PLAN COMMISSION/HISTORIC PRESERVATION COMMISSION WEDNESDAY, MARCH 23, 2022

1. Call to order – Roll call
2. Consider February 23, 2022 Plan Commission meeting minutes
3. Discussion on the proposed free-standing sign for Little Vikings Academy, 1991 Commerce Drive
4. Consideration applications of 110 and 108 E. Main Street and certificate of appropriateness.
 - a- Design Review
 - b- Certificate of appropriateness
5. Consider SIP and design review for mixed use development located at 1800 Springdale Street, further described as parcel 0607-072-9765-1
 - a- Site specific implementation plan
 - b- Design review
6. Plan Commission Chair report
7. Village Planner report
8. Adjourn

SPRINGDALE STREET APARTMENTS

SHEET NUMBER:
L1.0

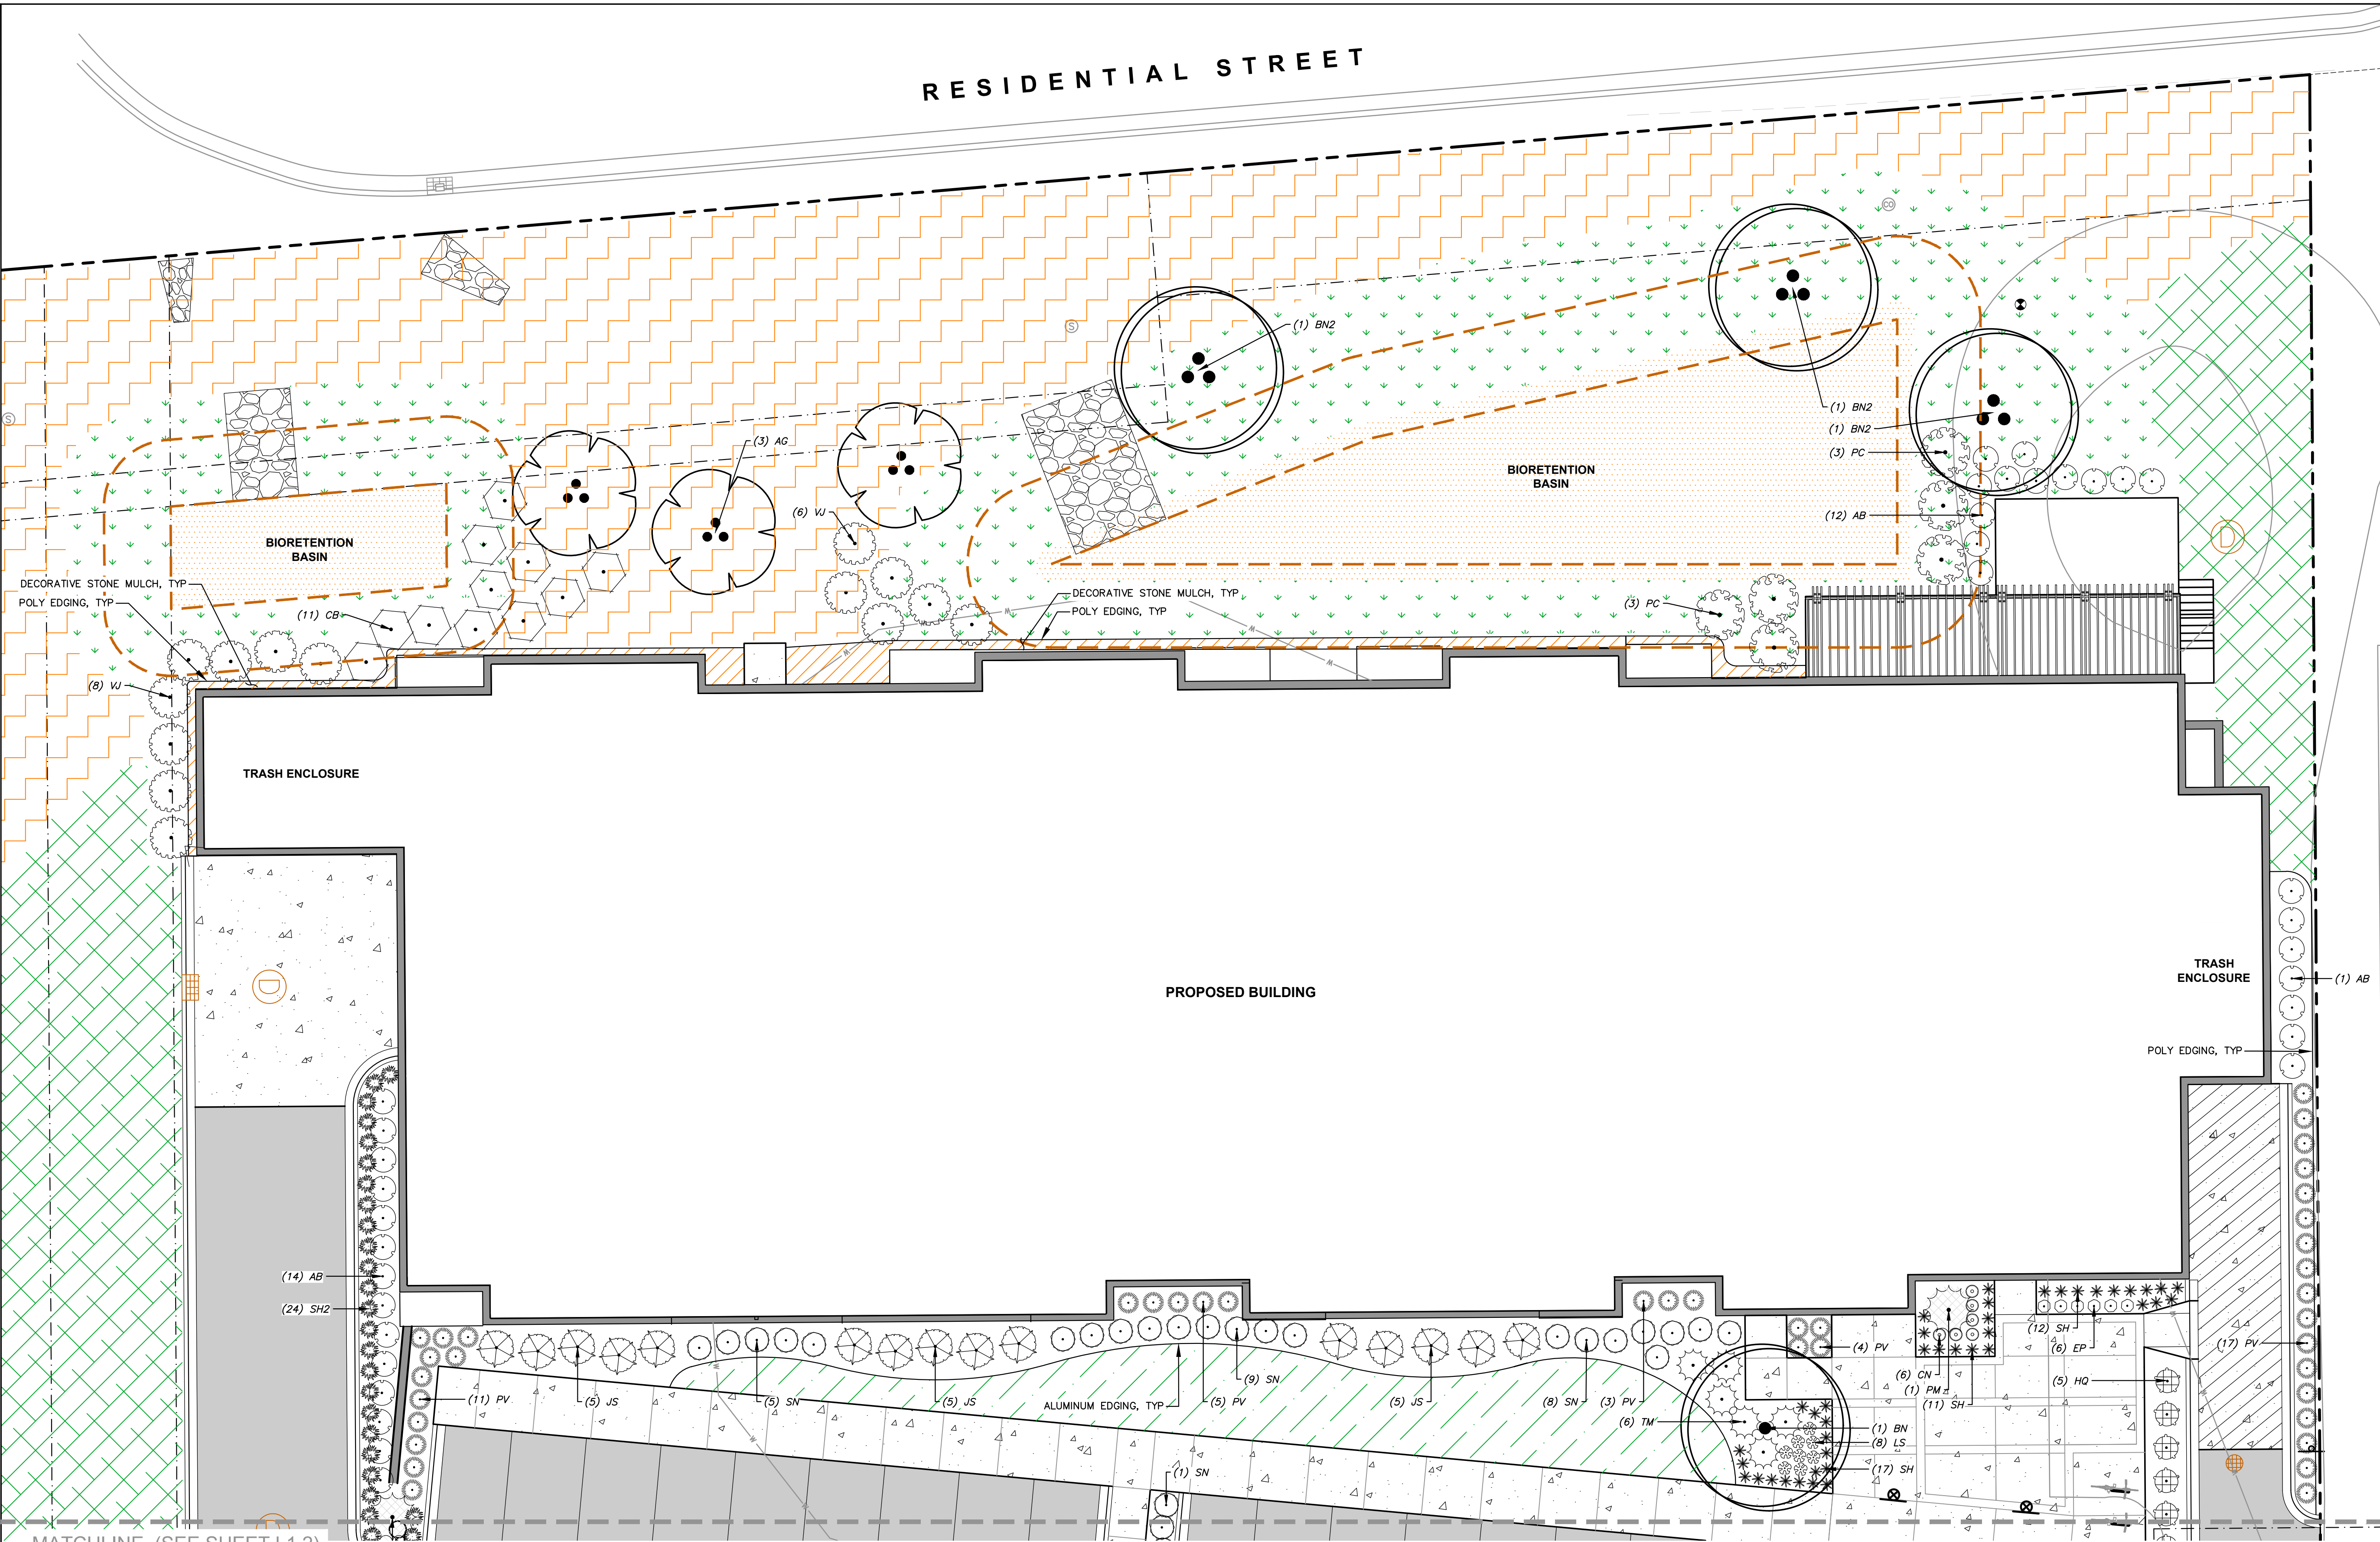
- a. Parking lot landscaping shall comply with the requirements of §17.136
 - This requirement is met with the number of parking area trees, landscape islands, and points provided in Sheet L1.0.
- b. Subsection 24.a., above, shall also apply along street and drive frontages.
 - Per the approved GDP, the requirement for minimum landscape frontage facing Springdale Street was removed. The SIP is consistent with the approved GDP. This requirement is met.
